Project Reference: 2408-037/TN/02

Technical Note

PROJECT TITLE: TRURO TOWN DEAL

Road Safety Audit – Stage 1

DRAWING TITLE: LIGHTERAGE HILL GENERAL ARRANGEMENT **MEASURES & CONSIDERATIONS**

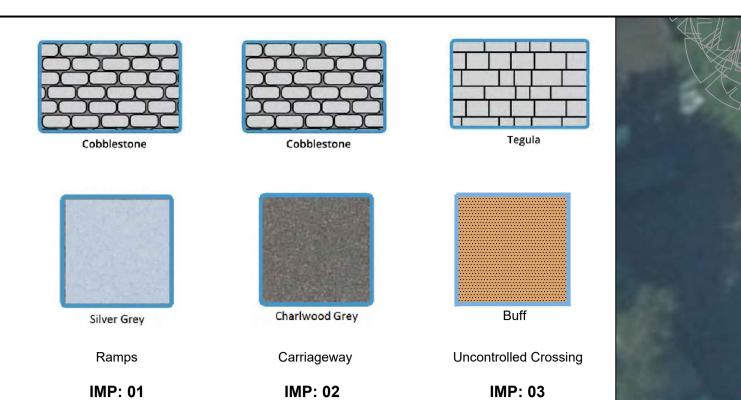
- 2.1 The proposed pedestrian and cycle improvements consist of changes to the surfacing materials of the carriageway across and adjacent to the junction, a widened shared footpath / cycle path along the north side of Lighterage Hill and an uncontrolled pedestrian crossing point that cuts diagonally across the junction, from the northwest corner of the junction to the entrance to the new bridge.
- 2.2 No improvements have been proposed on Newham Road to the north of the junction, which is the most direct route between the bridge and town centre / commercial areas to the north.

Vegetation clearance to improve pedestrian-driver inter-visibility at thecrossing point to Lighterage Quay

> Vegetation clearance and wall removal to improve pedestrian-driver nter-visibility at Newham Trail crossing point.

Proposed warning sign and marking -to highlight presence of crossing to motorists and reduce vehicle speeds
